Model: Stinger-C1 Paper Tray Unit / 2 Trays (PS410) Date					9	No.: MA860001
Modified Article:	Part number change	Prepared	by: ĸ.	Miura		
From: Technical Se	ervices Dept., GTS Division					
Reason for	☐ Parts catalog correction	∨end	lor ch	ange	☐ To n	neet standards
Modification:	☐ To facilitate assembly ☐ To improve			e reliability	()
	☐ Part standardization ☐ Other

Model: Stinger-C1 Paper Tray Unit/1Tray (PS410)				9: 15-Dec-9	9	No.: MA860002	
Modified Article: Spring Guard					Prepared by: K. Miura		
From: Technical Services Dept., GTS Division							
Reason for	Parts catalog correction	☐ Vend	or ch	ange	☐ To m	neet standards	
Modification: ⊠ To facilitate assembly ☐ To improv		o improve reliability		()		
☐ Part standardization ☐ Other

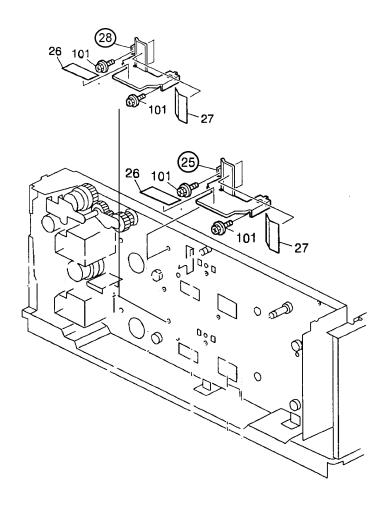
The shape of the spring guard has been modified to facilitate removal.

Old part	New part	Description	Q'ty	Int	Page	Index	Note
number	number						
A8601190	-A8601190	Guard: Spring: Paper Bank	2-1		11	25	
	A8601191	Spring Guard – Lower	1	O/O	11	28

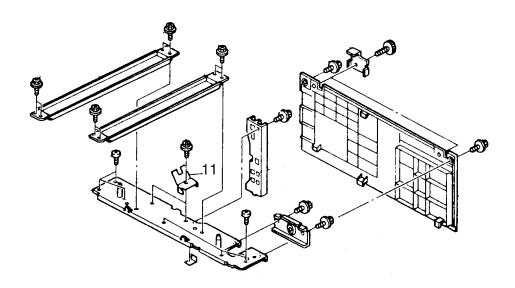
Date: 23-Mar-00 No.: MA860003 Model: Stinger-C1 Paper Tray Unit/2Trays (PS410) Modified Article: Mylar added to plate springs Prepared by: K. Miura From: Technical Services Dept., GTS Division ☐ Vendor change Reason for ☐ Parts catalog correction ☐ To meet standards (☐ To facilitate assembly ☐ To improve reliability Modification: Part standardization ○ Other

For increased safety, a mylar strip has been added to both plate springs located in between the paper feed unit and mainframe.

Old part	New part	Description	Q'ty	Int	Page	Index	Note
number	number						
H5194547	A8601140	Spring Plate	2	X/O	3	11

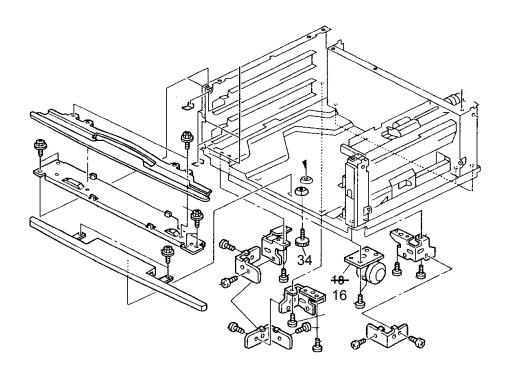
Model: Stinger-C1 Paper Tray Unit/2 Trays (PS410)					0	No.: MA860004
Modified Article: A	djusting pin added	Prepared by: K. Miura				
From: Technical Ser	vices Dept., GTS Division					
Reason for	Parts catalog correction	☐ Vendo	or ch	ange	☐ To m	neet standards
Modification: ☐ To facilitate assembly ☐ To improve			e reliability	()	
☐ Part standardization ☐ Other

An adjusting pin has been added to the Paper Tray Unit to make it easier to secure the unit in place. This will function in place of the Paper Tray Unit caster locks.

Old part	New part	Description	Q'ty	Int	Page	Index	Note
number	number						
AH012025	AH012026	Caster	2-4	X/O	3	18-16	
	A8601125	Adjusting Pin	1		3	34

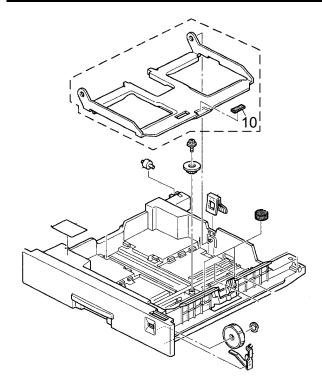
In order to ensure proper feed of OHP transparencies, a material with a lower rubber content is now used for the bottom plate pad. This material has a lower coefficient of friction and is effective against the following OHP feed symptoms.

- Last sheet non-feed (jam display)
- Skewing
- Noise

Old part	New part	Description	Q'ty	Int	Page	Index	Note
number	number						
G0292608	52152713	Bottom Plate Pad	1	X/O	5	10

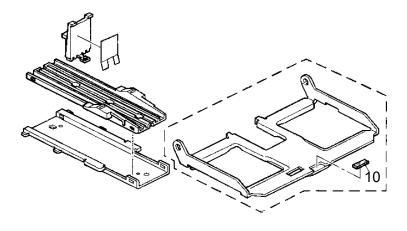
Due to the measurement specifications of the bottom plate pad, it is possible for the pad to be wider than the opening in the bottom plate. To ensure that the pad will fit in the opening, the base pad for the Russian will be used.

Old part	New part	Description	Q'ty	Int	Page	Index	Note
number	number						
52152713 —	7	Bottom Plate Pad	1	0/0	5	10	
	^L A2672917	Base Pad	1	0/0	5	10

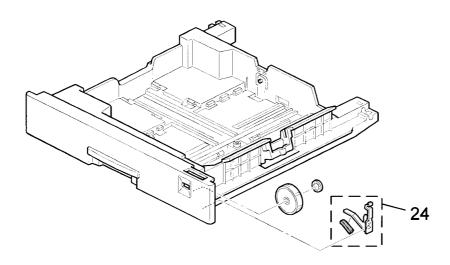
The edge of the spring pate for the paper size dial is relatively sharp. To ensure proper safety, a sponge has been added to the plate.

Old part number	New part number	Description	Q'ty	Int	Page	Index	Note
A2672868	A2672870	Sponge – Spring Plate	1	X/O	5	24

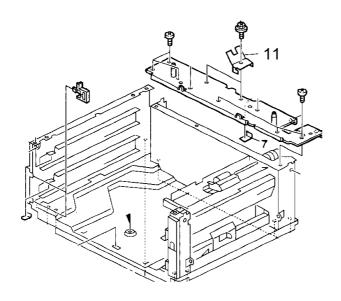
Although previously, a mylar was added to the spring plate to protect it from damage (MB #MA861003), the shape of the spring plate itself has now been modified to perform the same function.

Old part number	New part number	Description	Q'ty	Int	Page	Index	Note
A8601140	B3841146	Spring Plate	2	X/O	3	11

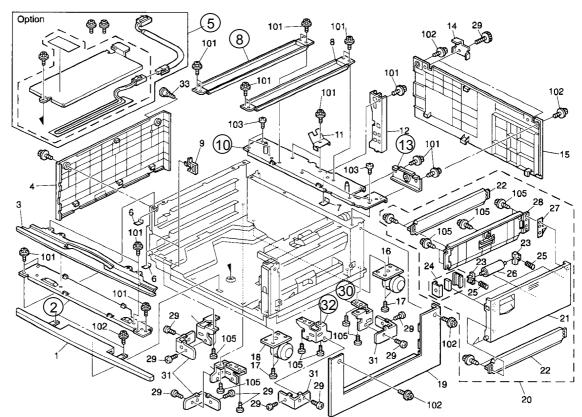
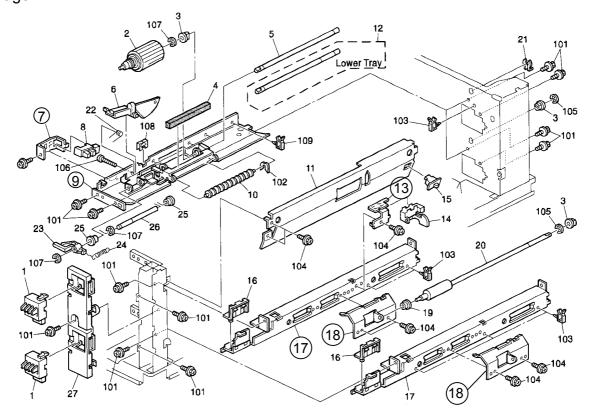
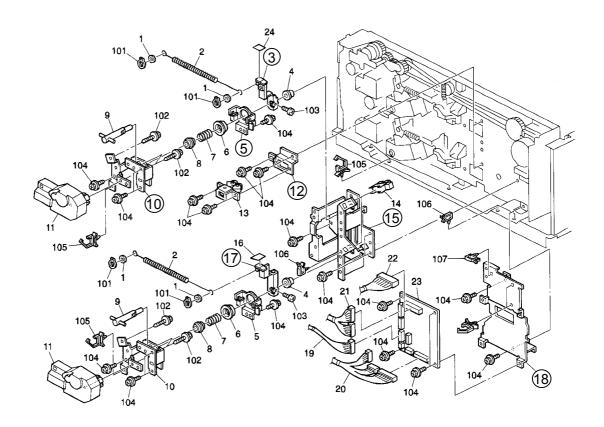
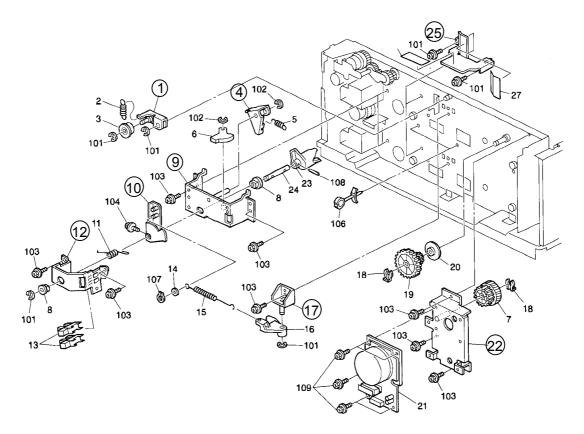
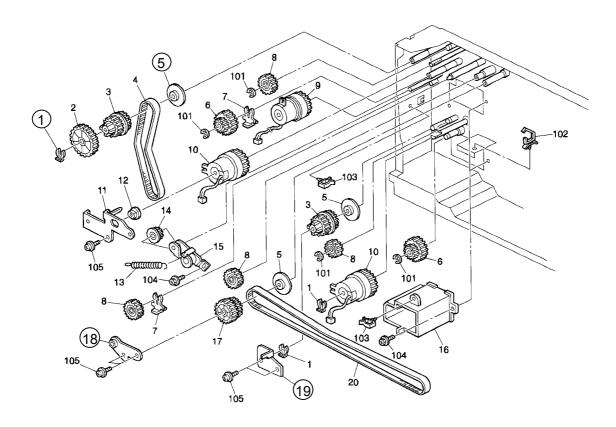
A material change has been applied to the following brackets and bracket portions of the following components.

Old part	New part	Description	Q'ty	Int	Page	Index	Note
number	number						
A8601110	B3841110	Upper Front Stay	1	O/O	3	2	
A8601114	B3841114	Upper Rear Stay	1	O/O	3	10	
A8601117	B3841117	Bracket - Upper Rear Stay	1	O/O	3	13	
A8601120	B3841120	Upper Left Stay	2	O/O	3	8	
A8606260	B3846260	Unit Holder Bracket - LF/RR	2	O/O	3	30	
A8606270	B3846270	Unit Holder Bracket - RF/LR	2	O/O	3	32	
A8606300	B3846300	Tray Heater	1	O/O	3	5	
A2672660	B0242660	Vertical Sensor Bracket	1	O/O	7	13	
A2672805	B0242805	Bracket - Paper End Sensor	2	0/0	7	7	
A2672842	B0242842	Bracket - Friction Pad Guide	2	O/O	7	18	
A8601090	B3841090	Right Guide Rail	2	O/O	7	17	
A8602555	B3842555	Feed Roller Bracket	2	0/0	7	9	
A2672908	B0242908	Tray Holder Bracket	2	0/0	9	12	
A8601161	B3841161	Interface Board Bracket	1	O/O	9	18	
A8602709	B3842709	Upper Lever - Lift Motor	1	0/0	9	3	
A8602720	B3842720	Main Bracket - Lift Motor	1	0/0	9	15	
A8602726	B3842726	Lift Motor Bracket	2	0/0	9	10

A8602728	B3842728	Spring Holder Bracket	2	0/0	9	5	
A8602895	B3842895	Lower Lever - Lift Motor	1	0/0	9	17	
A2672765	B0242765	Pressure Lever Stopper	1	0/0	11	4	
A2672773	B0242773	Lift Sensor Bracket	1	0/0	11	12	
A2672781	B0242781	Pressure Lever Bracket	2	0/0	11	17	
A2672815	B0242815	Main Bracket - Pressure Lever	1	0/0	11	9	
A8601190	B3841190	Upper Spring Guard	1	0/0	11	25	
A8601191	B3841191	Lower Spring Guard	1	0/0	11	28	
A8602810	B3842810	Main Motor Bracket	1	0/0	11	22	
A8602821	B3842821	Timing Belt Tensioner	1	0/0	11	1	
A8602893	B3842893	Actuator - Paper Height Sensor	2	O/O	11	10	
A2672602	B0242602	Timing Belt Tensioner	1	O/O	13	5	
A8602840	B3842840	Bracket - Paper Feed Clutch	1	O/O	13	1	
A8602850	B3842850	Lower Bracket - Paper Feed	1	O/O	13	19	
A8602860	B3842860	Upper Bracket - Paper Feed	1	O/O	13	18

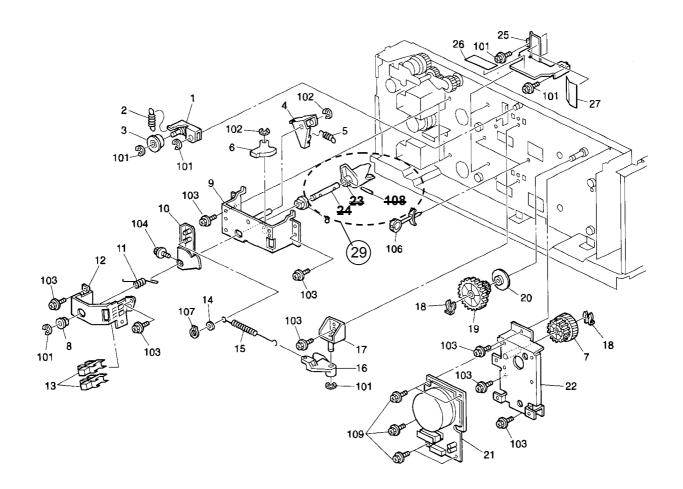
Please correct your Part Catalog as follows:

Old part	New part	Description	Q'ty	Page	Index	Note
number	number					
A2672761 -		Joint – Shaft	1	11	23	
A2672762 -	•	Shaft	1	11	24	
06230140E -		Spring Pin – 3x14mm	1	11	108	
	L A2672756	Joint - Shaft	1	11	29

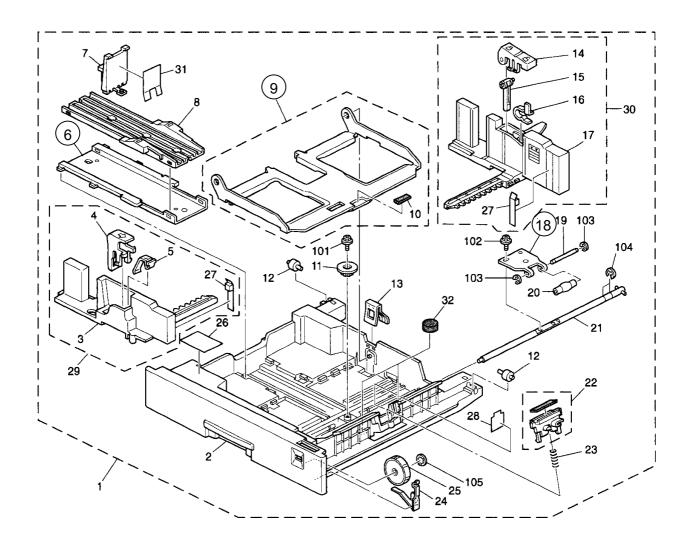
A material change has been applied to the following brackets and bracket portions of the following components.

Old part	New part	Description	Q'ty	Int	Page	Index	Note
number	number						
A2672874	B0242874	Base Slider	1	O/O	5	6	
A2672861	B0242861	Bottom Plate	1	O/O	5	9	
A2672856	B0242856	Bracket - Rising	1	0/0	5	18

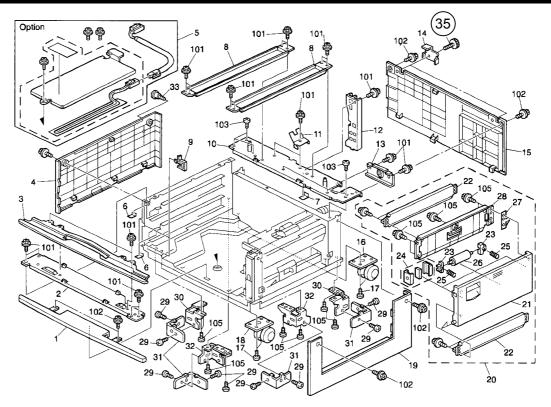
To maximize the Rear Cover's resistance to warping under high temperatures (over 60°C), the M4x10 Flat Knob Screw for the cover has been changed to an M4x11 screw in the **two** areas shown below (index 35).

Note: Since the M4x10 screw (index 29) is still being used in the remaining areas, its service parts quantity has been changed from 10 to 8 with no P/N change.

Old part	New part	Description	Q'ty	Int	Page	Index	Note
number	number						
AA143508	- AA143508	Flat Knob Screw – M4x10	10-8		3	29	
	AA143775	Screw: M4x11	2	X/O	3	35

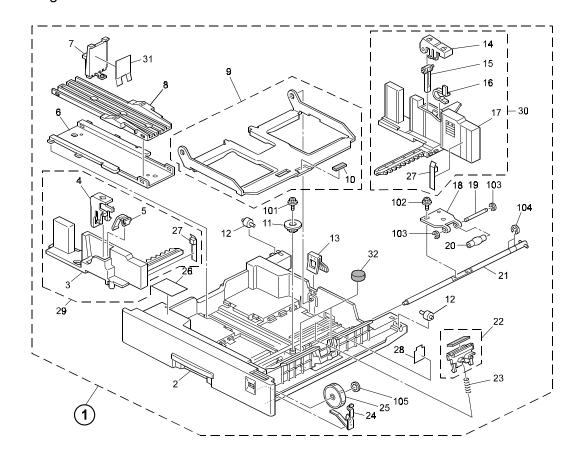
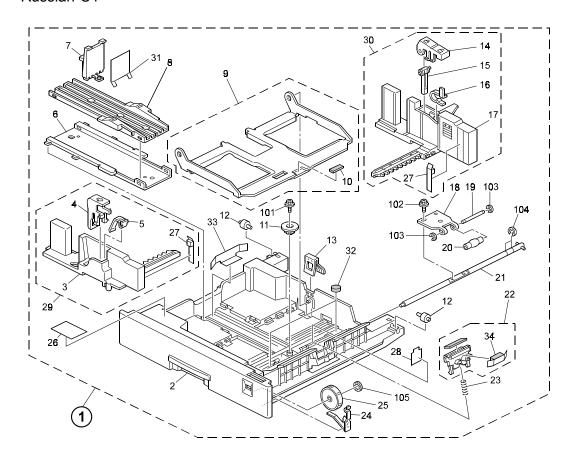
The following has been changed to ensure that the Paper Tray can be inserted and pulled out more smoothly.

Old part number	New part number	Description	Q'ty	Int	Page	Index	Note
A8607341	A8607342	Paper Tray Assembly	1	0/0	5	1
